ClinchRiverESPHFNPEm Resource

From: Schiele, Raymond Joseph <rjschiele@tva.gov>
Sent: Thursday, January 11, 2018 11:07 AM
To: Dozier, Tamsen
Cc: Fetter, Allen; Stout, Daniel Paul
Subject: [External_Sender] RE: timing for a chat
Attachments: DRAFT Clinch River Environmental Audit Report - TVA Comments.docx

**Clinch River Nuclear Site
Early Site Permit Application
Environmental Audit Summary Report**

CRN Site Location

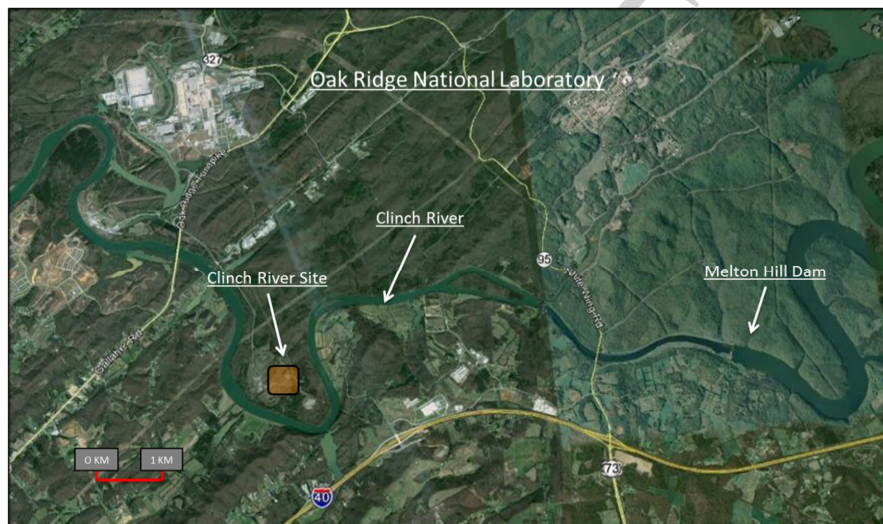
Commented [CKE1]: Remove shaded block at Clinch River Site pointer - the peninsula is the site
